FLIGHT DESIGN USA SAFETY DIRECTIVE No.15

Revision 1

Trim Tab Reinforcement

Fig B1 & B2: Reinforcement installed to the trim tab
(Tab shown bottom surface facing up)

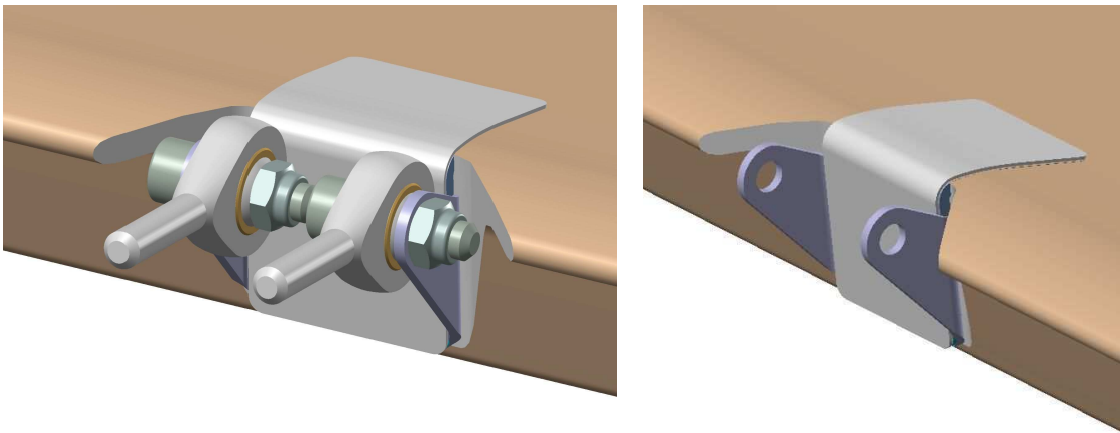
The reinforcement procedure consists of reinforcing the point at which the control horn is bonded to the trim tab by the addition of specifically designed part manufactured by Flight Design (WA 3011011). The part is glued (bonded) to the control rod bracket and the lower trim tab surface with resin and delivers a secondary load path for the trim tab control forces.

The modification can be done without removing the trim tab, and does not require painting. (Figs.B1 & B2)
